Interactive comment on "Two fast temperature sensors for probing of the Atmospheric Boundary Layer using small Remotely Piloted Aircraft (RPA)" by N. Wildmann et al.

N. Wildmann et al.

Received and published: 21 June 2013

Fig. 1. Schematic drawing of the complete thermocouple measurement strategy.

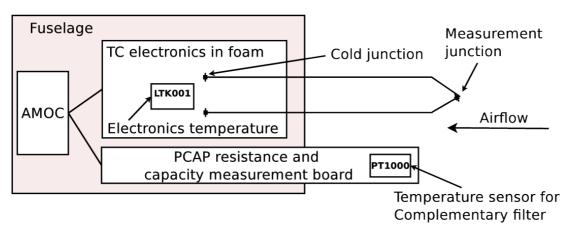
- 3. *line 149: I suggest to use consistently RPA/RPAS instead of UAV*The term RPA is will consistently be used in a revised manuscript.
- 4. figure 3: hard to read, in particular the very small letter size, I suggest to increase the figure or at least the fonts

The font size was increase, see figure 1.
